RE: Howard County, Maryland Comments on MAA
Draft Environmental Assessment

Howard County Comments on the MAA Draft EA for Airport Expansion (2018)

Figure 1A Runway 28 Departures - shows specific examples of aircraft flying where they were not flying prior to DC Metroplex/NextGen.

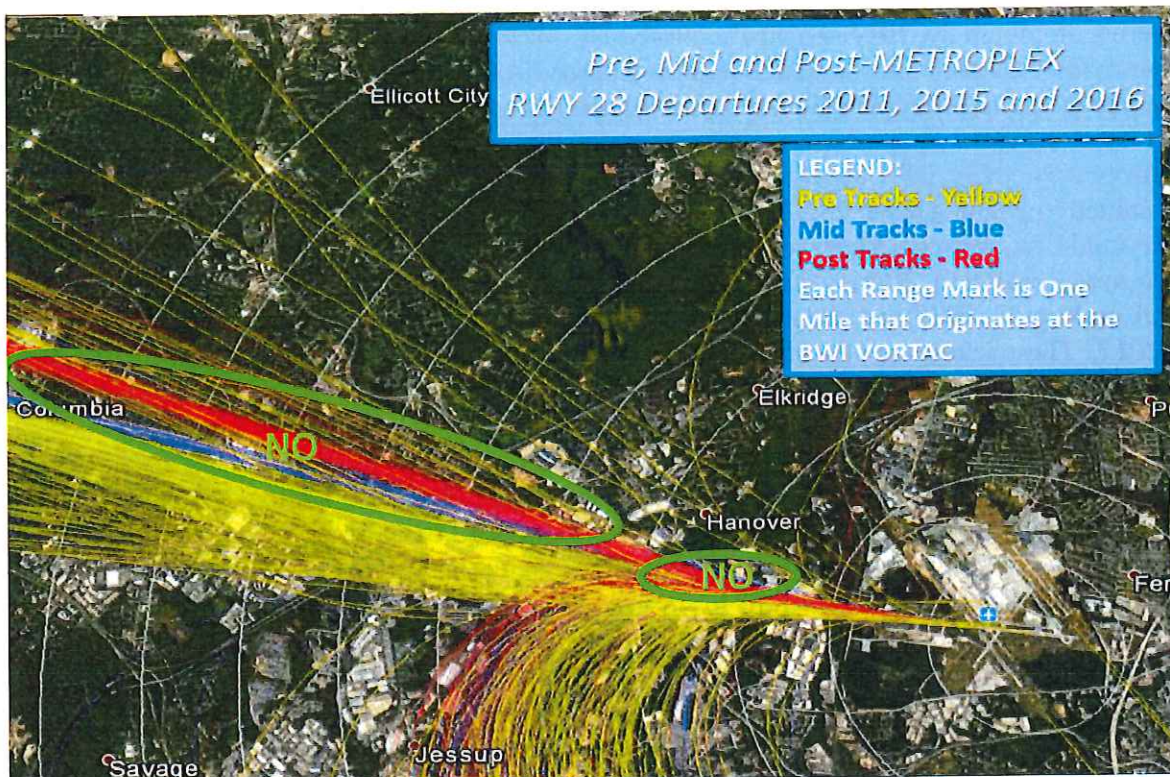
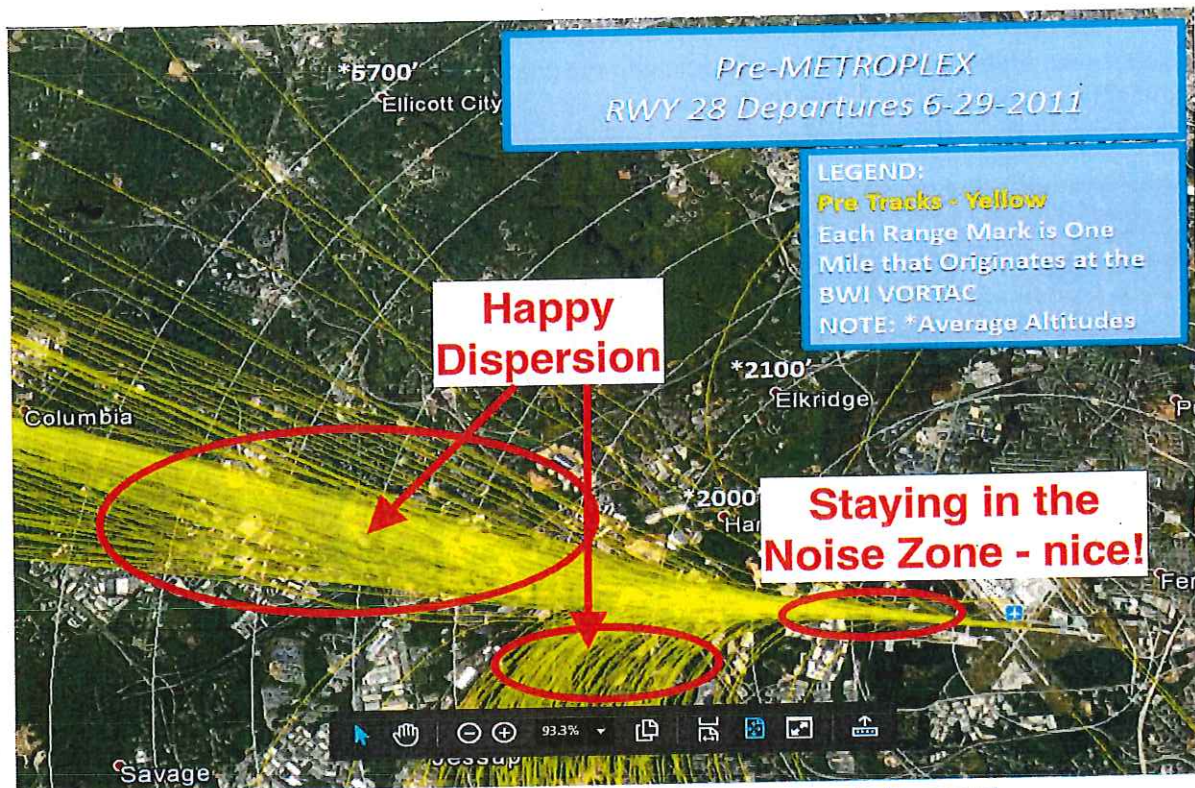
1. New flight paths have been created by DC Metroplex/NextGen; FAA must revert to old flight paths. Thousands of community residents have observed aircraft flying along flight paths that were not being flown previously. See Figures 1A, 2A and 3A and FAA flight path diagrams in Attachments 1 and 6 for comparison and as representative examples. These new flight paths include, among others:

- Runway 28 departure – early turn and path shift to the north and flying south at low altitude
- Runway 15 departure – earlier and lower turn
- Runway 33L and 10 arrivals – flights cleared direct to any waypoints from the RAVNN arrival (including waypoints GRAFE, SPLAT, JANNNS)

Figure 1B Runway 28 Departures – shows pre-DC Metroplex/NextGen features that need to be restored.

Figure 3A Runway 33L Arrivals - as well as figures 1 and 2 above, show examples of how planes are now concentrated into narrow corridors so that plane after plane are destructive for the residents beneath.

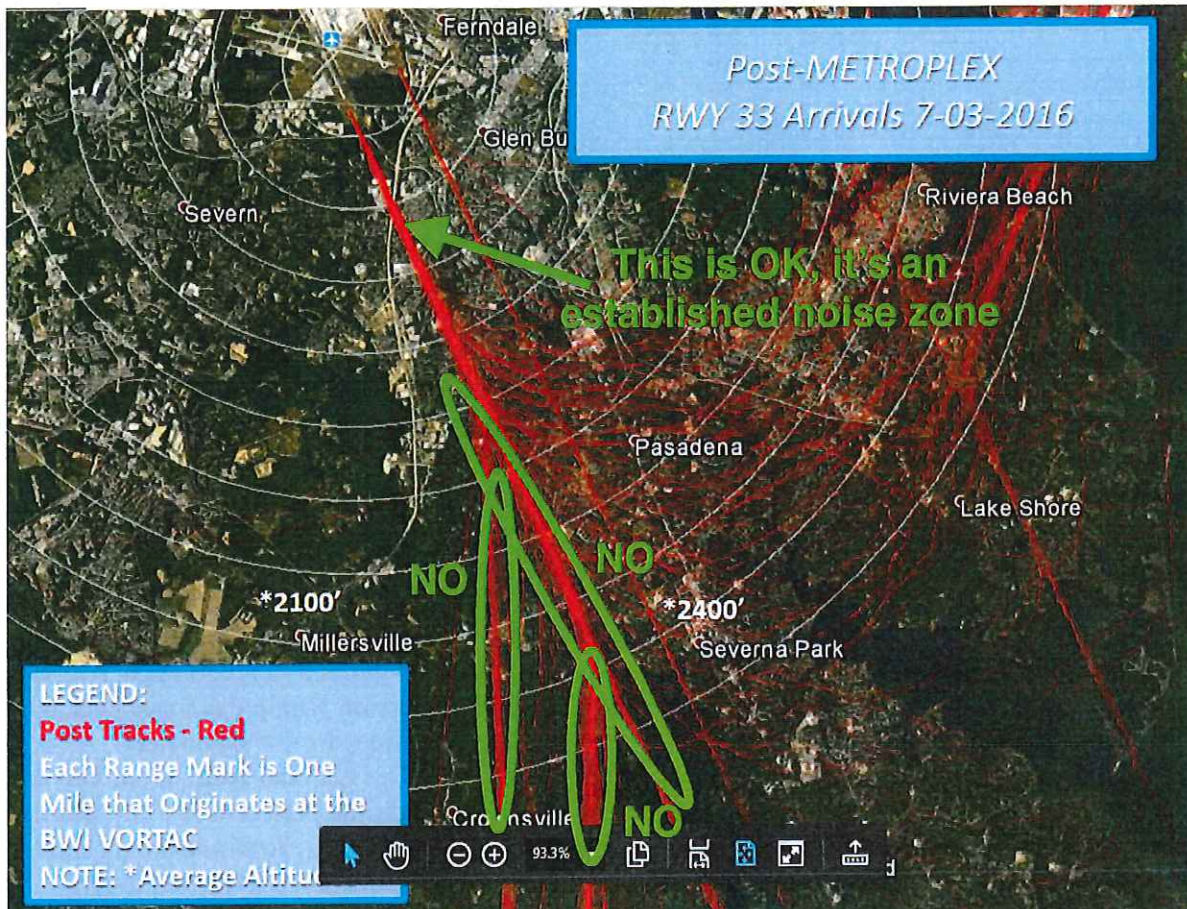
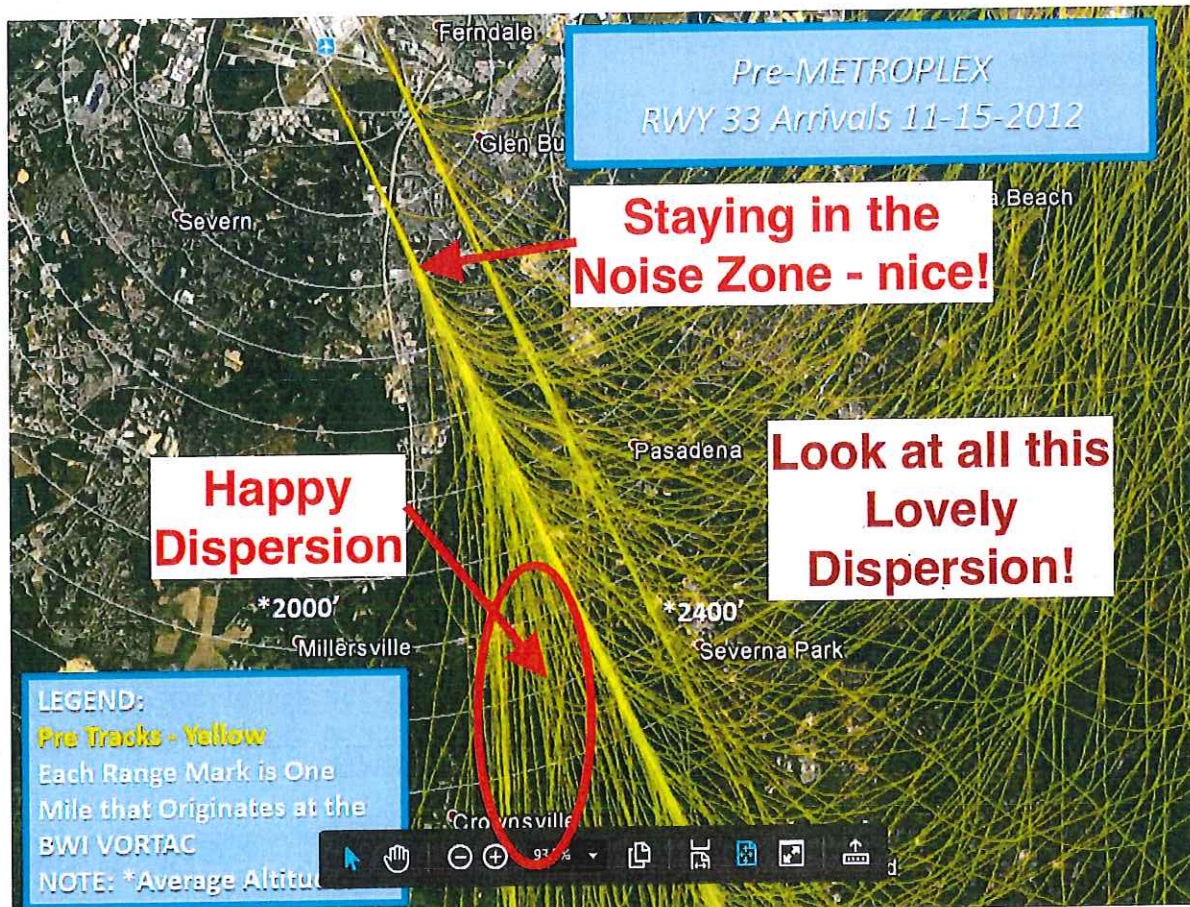
2. DC Metroplex/NextGen has resulted in a concentration of flight paths in narrow corridors; FAA must revert to old procedures that were effective in achieving dispersion. The concentration of low flying aircraft along the departure and arrival flight paths has been disastrous for residents underneath them. Numerous studies have demonstrated the harmful effect on mental and physical health due to aircraft and low frequency noise. In addition to the health effects, there is a questionably constitutional taking by the FAA of the residents' quiet and peaceful enjoyment of their homes and attendant economic loss due to lower property values. A comparison of pre- and post-DC Metroplex/NextGen flight paths as shown on Attachments 1 and 6 clearly shows the concentration of flight paths post-DC Metroplex/NextGen and that those under the flight paths would be significantly impacted is intuitive.

The June 20 presentation did not provide for notional zones to deal for dispersion on arrivals, but notwithstanding the presentation, Ms. Ray communicated at the meeting and in subsequent communications that the FAA understands the problem of concentration and the request for dispersion (examples of which are shown on Attachment 1) and would undertake efforts to recreate that dispersion on arrivals.

Figure 3B Runway 33L Arrivals - shows dispersion and features of pre-DC Metroplex/NextGen arrivals that must be restored.

Figure 4 Vertical Profiles – shows how planes are flying at lower altitudes than necessary, as has been observed on all arrivals, particularly bothersome with arrivals on Runway 33L and Runway 10.

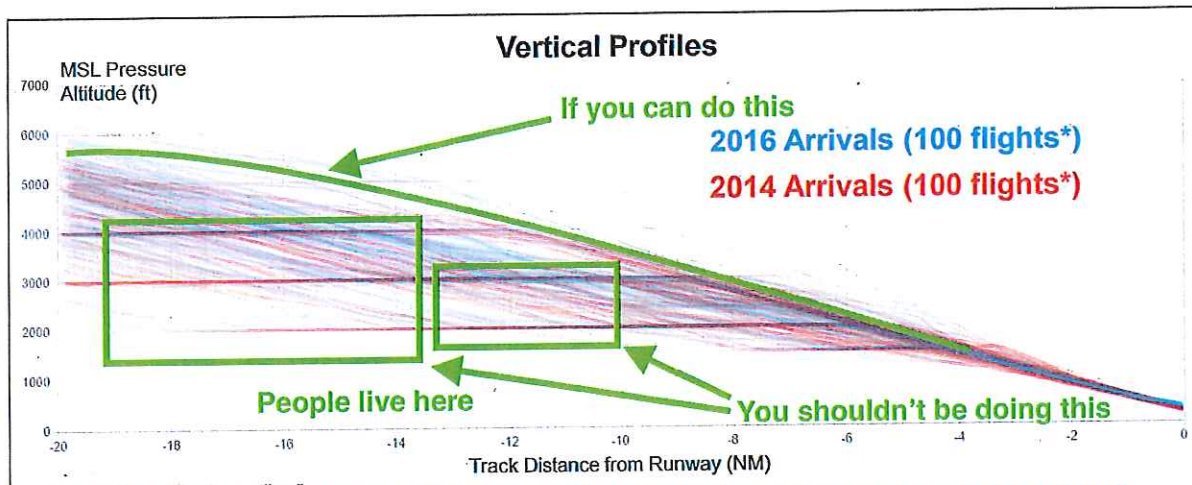
3. FAA procedures permit aircraft to fly at altitudes too low; procedures must be modified to require aircraft to fly at the highest safe altitude at all times during departures and arrivals. Residents universally state that aircraft are flying lower under the DC Metroplex/NextGen scheme than previously. We understand there is conflicting data about how low aircraft are flying and issues regarding whether representations regarding aircraft altitude in DC Metroplex environmental assessment were accurate. As stated by FAA operations representatives for BWI approach control, the frequent ATC procedure of clearing aircraft for visual approaches has had the effect of alleviating an aircraft's obligation to comply with published arrival and approach procedure altitudes resulting in much lower flying aircraft. This has directly translated into an unacceptably lower altitude for regular flight operations. For arrival aircraft this has affected flights from as far out as the RAVNN waypoint on the RAVNN arrival and their joining of the final approach corridor into 33L at lower than IFR standard glideslope intercept altitudes. For 15R departures this has resulted in aircraft turning at lower altitudes; altitudes should be restored to previously established altitudes and the turn should be restored to 1 DME.
